## Product Change Notice (PCN)

**Subject:** RZ/V2N Product Mask Version Change

**Publication Date:** 6/25/2025

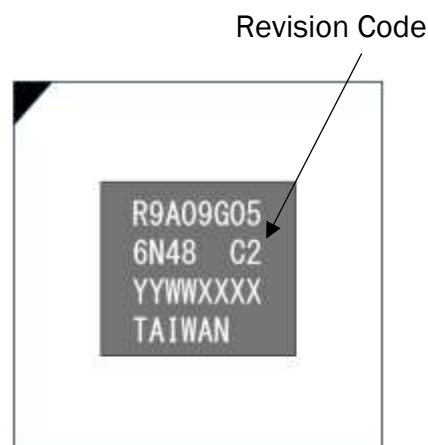
Fixing the DDR Memory Controller issue.

Revised products can be identified by the revision code 'C2' marked on the package or by reading the value from the LSI Device ID register. Additionally, for the revised products, the last digit of the booking part number will be changed from 0 to 1.
